ENVIRONMENTAL BUSINESS CONSULTANTS

Re: 14CVCP246K
E-Des # 11EHAZ316K
505 Union Street
Remedial Action Work Plan (RAWP) Stipulation List

Environmental Business Consultants (EBC) of New York hereby submits a Remedial Action Work Plan (RAWP) Stipulation List for the Site to the New York City Office of Environmental Remediation (OER) on behalf of Express Builders. This letter serves as an addendum to the RAWP to stipulate additional content, requirements, and procedures that will be followed during the site remediation. The contents of this list are added to the RAWP and will supersede the content in the RAWP where there is a conflict in purpose or intent. The additional requirements/procedures include the following Stipulation List below:

FIRST FLOOR AND FOUNDATIONS PLAN

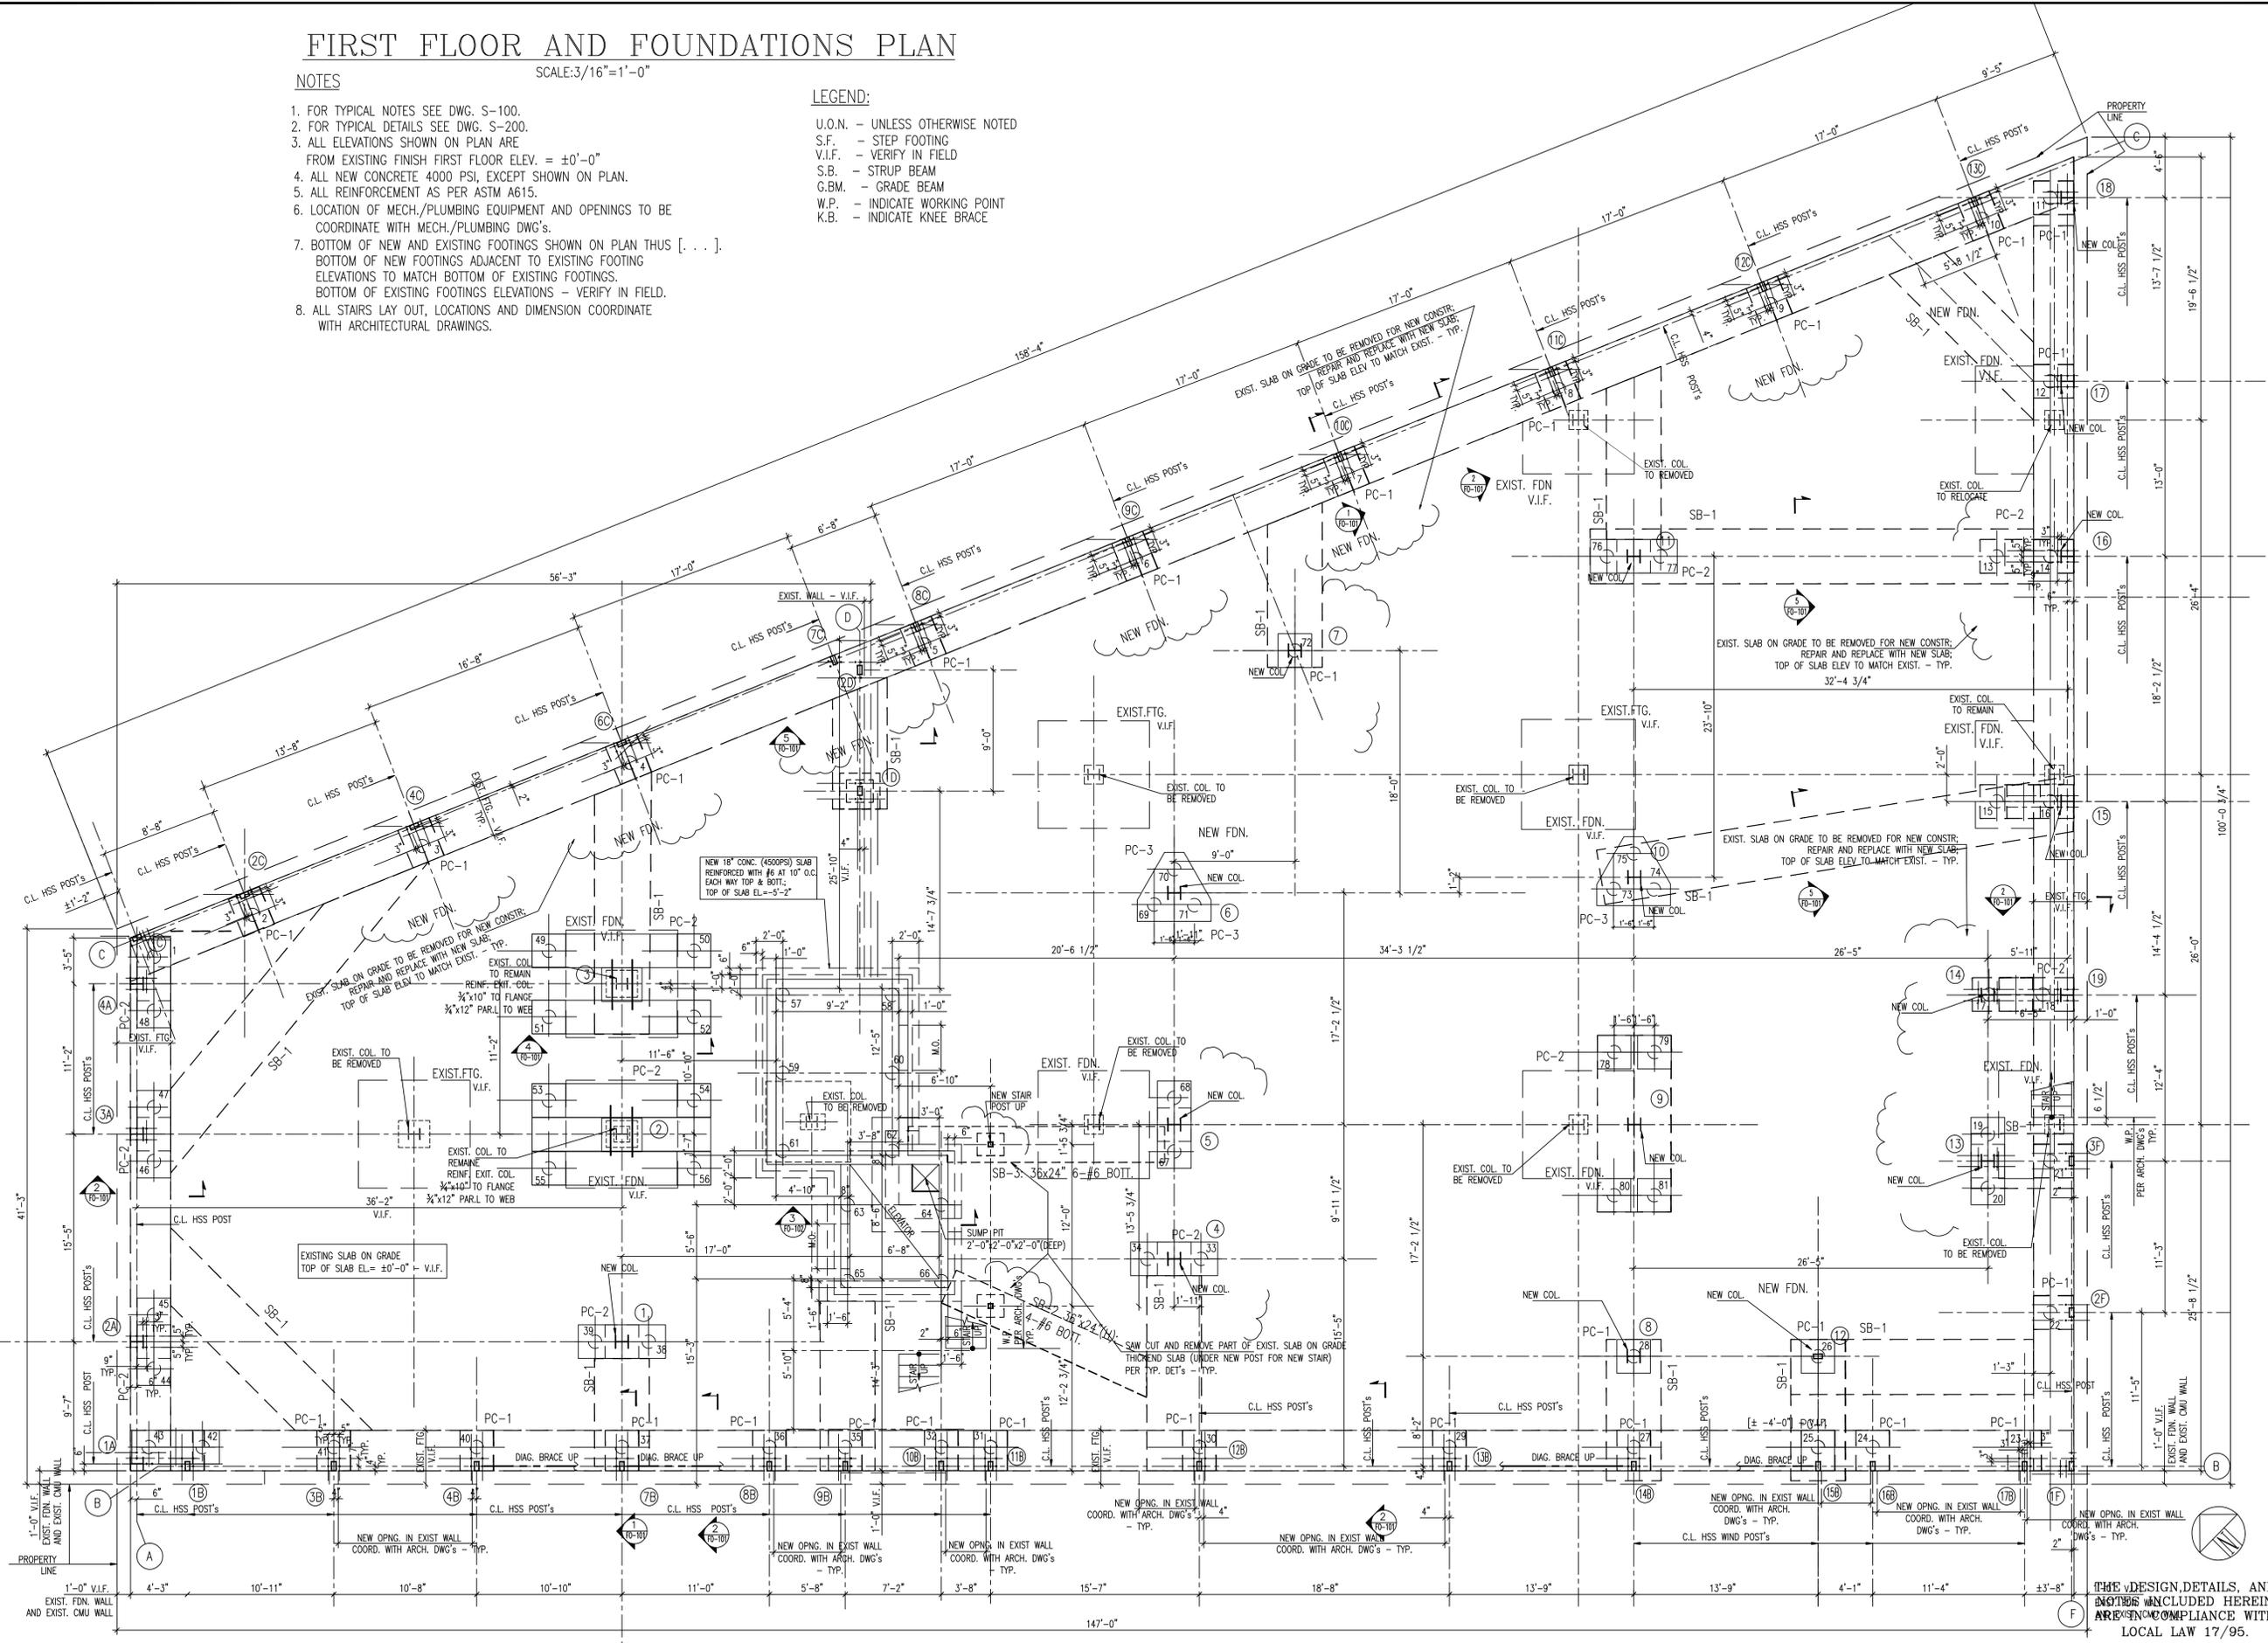
9. A 20-millimeter vapor barrier will be installed beneath portions of the structure's slab. The barrier chosen for this project is VaporBlock 20 Plus manufactured by Raven Industries. **Appendix 6** provides manufactures specifications and PE/RA certified building plans with the extent of the vapor barrier installation details (penetrations, joints, etc.) with respect to the proposed foundation, footings, etc.
10. Dewatering will be performed in full compliance with applicable laws, rules and regulations. Dewatering permit will be obtained from NYCDEP prior to construction activities.
11. The stamped/signed RAWP certification page is included in **Appendix 7**.
12. Development plans showing the elevator pit depth and pile locations are attached in **Appendix 8**.
